ADDENDUM NO. 001

Architects Project No.: 23042

Project Name: Ralston Apartment Renovations

- UNDERCUT DOOR BY 1"
- PROVIDE LOUVERED VENT

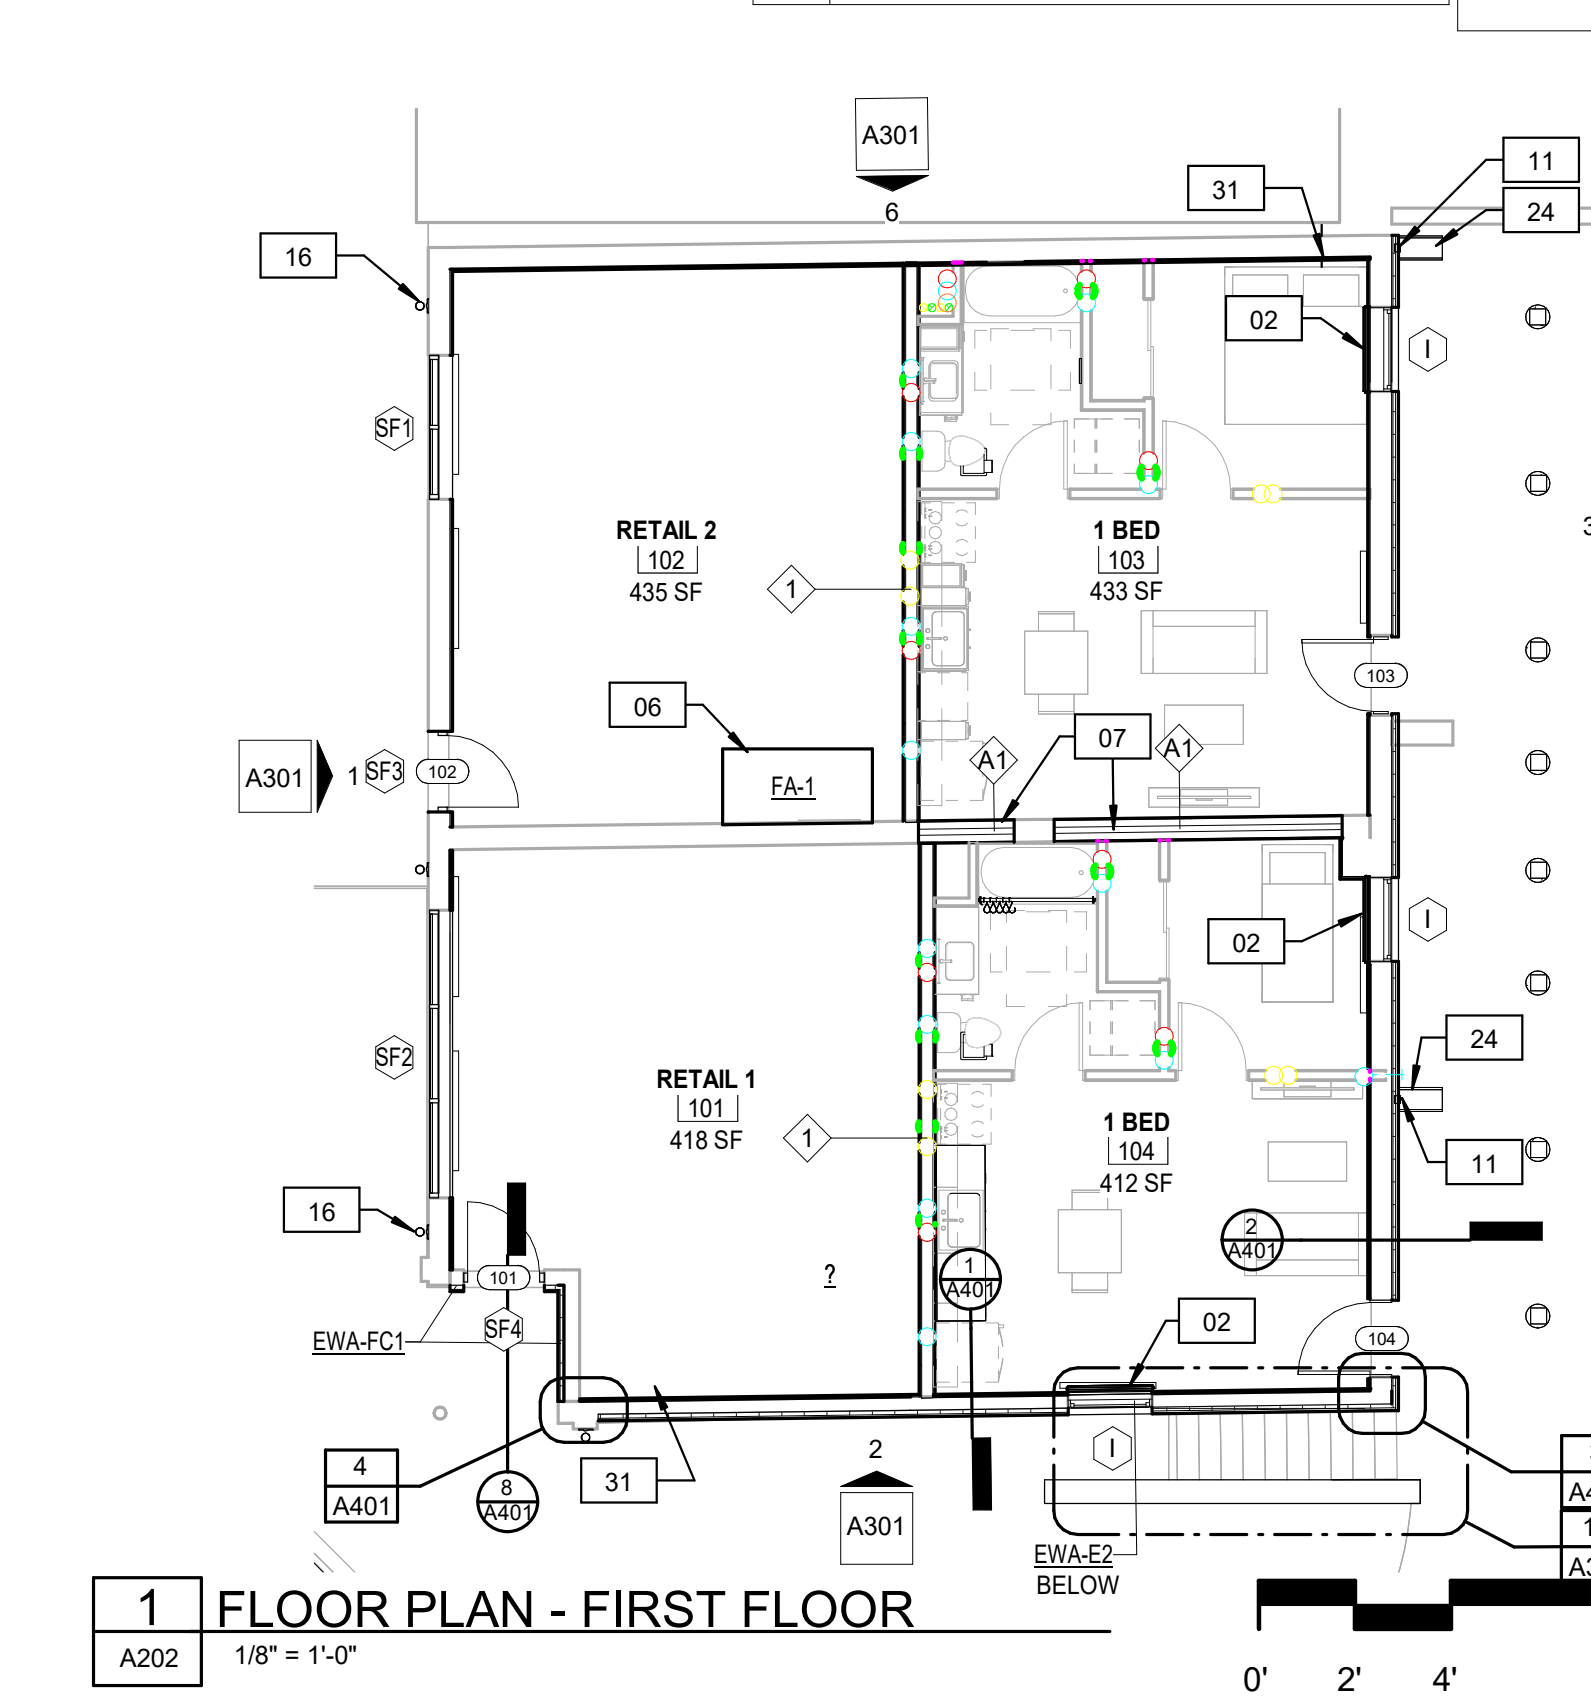
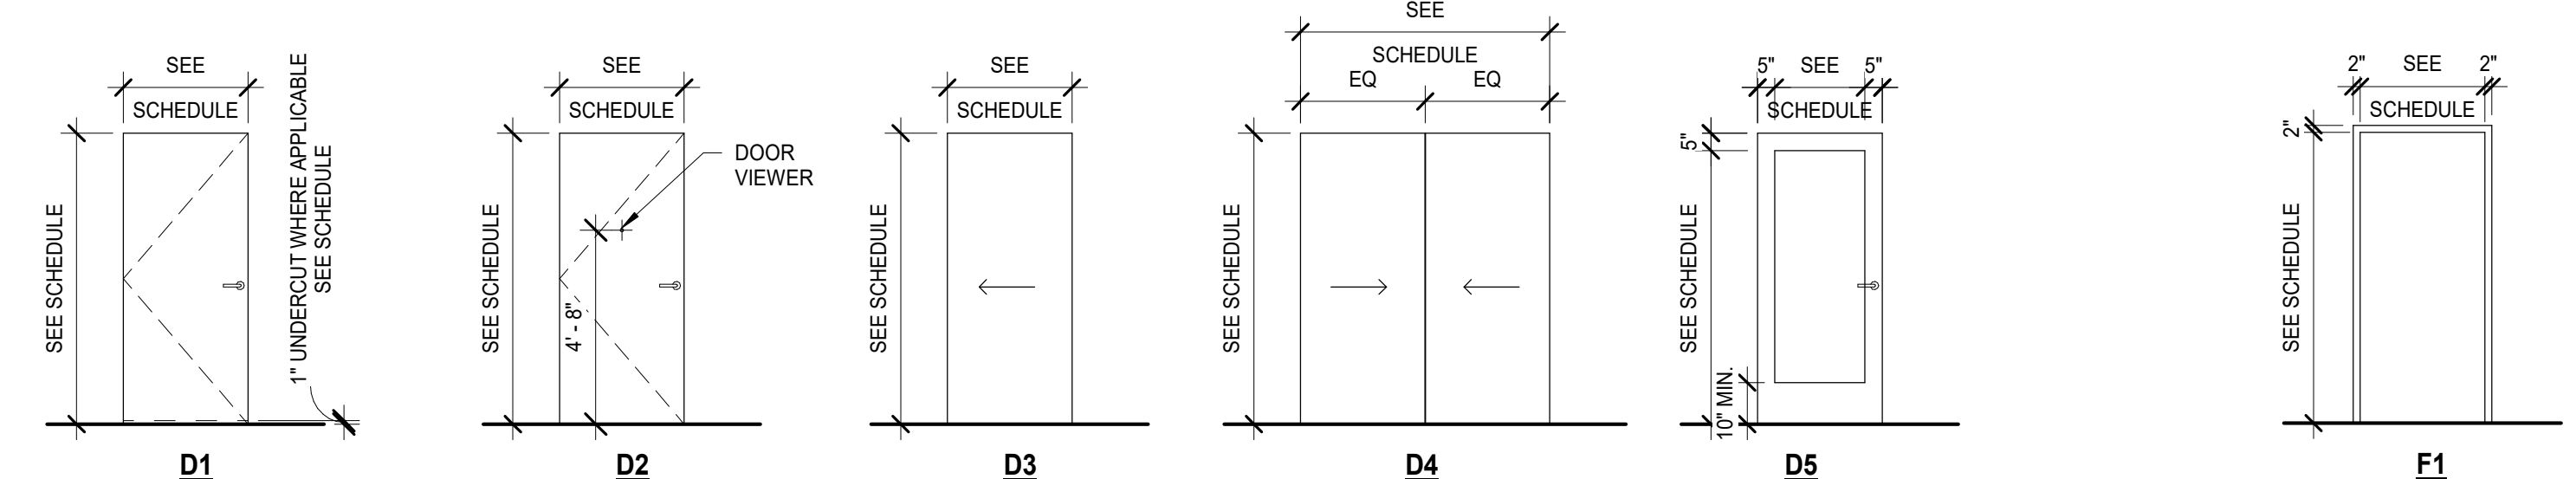
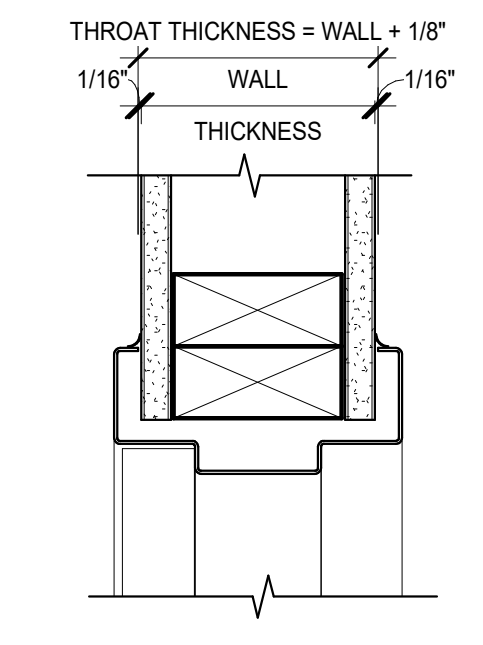
- a. See revised sheet A202 FLOOR PLANS, WALL TYPES, DOOR AND WINDOW SCHEDULES in Addendum 1
6. What thickness of Corian countertops are you looking for?

- a. Added basis of design and size information to windows in response to RFI-01.
 - b. Added resilient channels to walltype 1 and removed a layer of GWB.

- c. Showing hardware sets.
 - d. Specified paint color for doors and frames where indicated.
 - e. Staggered studs at walltype A1.
3. Sheet - A203 UNIT PLANS
